Access Compliance Report Public Rights-of-Way (Curb Ramps)

Intersection ID: N/A	Main Street: PAMPLIN_CT	Cross Street: PAISLEY_ABBEY_LN	Location: SE
ADA ID: B8E3CC59D151	Ramp Type: Perp	Initial Pass/Fail: Fail	Overall Compliance: No Severity Score: 18.75

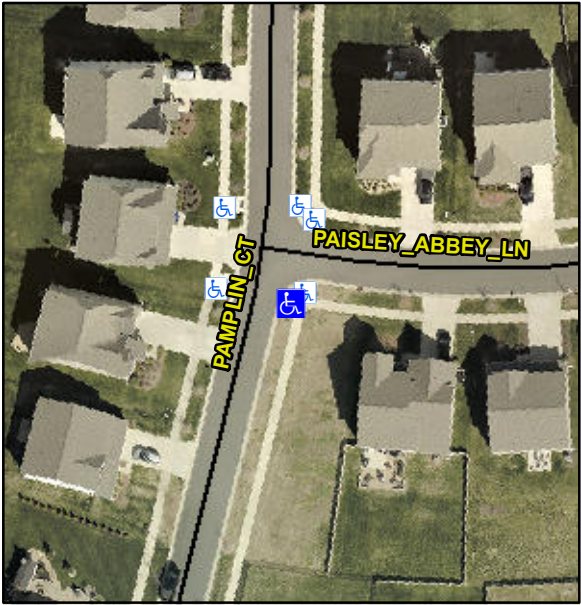
PROW/ADA:
Not Found, R304.5.1

Compliance	Description	Data	Compliance	Description	Data
N/A	Ramp Length (in)	96.0	Yes	Ramp Slope (%)	7.5
No	Ramp Width (in)	35.0	Yes	Ramp XSlope (%)	2.1
N/A	Flare Type LT	N/A	N/A	Flare Type RT	N/A
N/A	Flare Slope LT (%)	N/A	N/A	Flare Slope RT (%)	N/A
N/A	Flare Traversable LT?	N/A	N/A	Flare Traversable RT?	N/A
N/A	Landing Length (in)	N/A	N/A	DWS Provided?	N/A
N/A	Landing Width (in)	N/A	N/A	DWS Contrast?	N/A
N/A	Landing Slope (%)	N/A	N/A	DWS Length (in)	N/A
N/A	Landing X Slope (%)	N/A	N/A	DWS Full Width?	N/A
N/A	Landing Curb? (Y/N)	N/A	N/A	DWS Offset (in)	N/A
N/A	Shared Landing?	N/A			
N/A	Gutter Ponding?	N/A	N/A	Gutter Slope (%)	N/A
N/A	Gutter Lip Ht (in)	N/A	N/A	Gutter X Slope (%)	N/A
N/A	Painted X Walk1?	No	N/A	Painted X Walk2?	N/A
	X Walk 1 Direction	To NW		X Walk 2 Direction	N/A
N/A	X Walk 1 Width (in)	N/A	N/A	X Walk 2 Width (in)	N/A
	X Walk 1 Slope (%)	4.9		X Walk 2 Slope (%)	N/A
	X Walk 1 X Slope (%)	2.8		X Walk 2 X Slope (%)	N/A

Possible Solutions:
Remove & Replace Entire Ramp.
